Product Change Notification

PCN-IFC-9381-2024

Business Unit	Product Line Code	Type of Change	Action	Date of Issue
IFC - Industrial Field Connectivity	BF7	Product Change Notification	Notify Distributors and Field	1/19/2024

Description for Product Change Notification

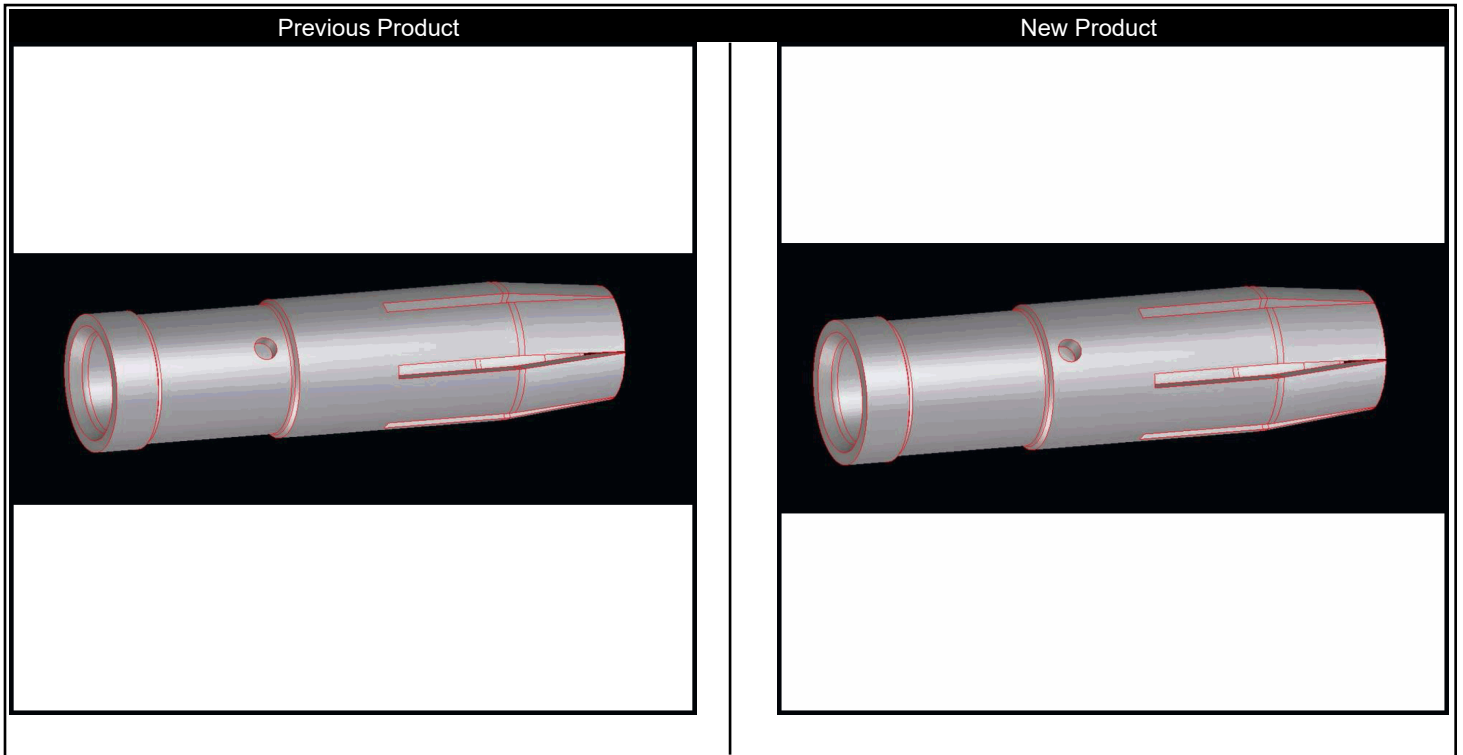
The inspection hole for the CK4,0 crimp contacts has been moved by approximately 2mm. It has moved from the crimping area toward the contact pin/socket mating area. This change better accommodates processing in automatic crimping devices.
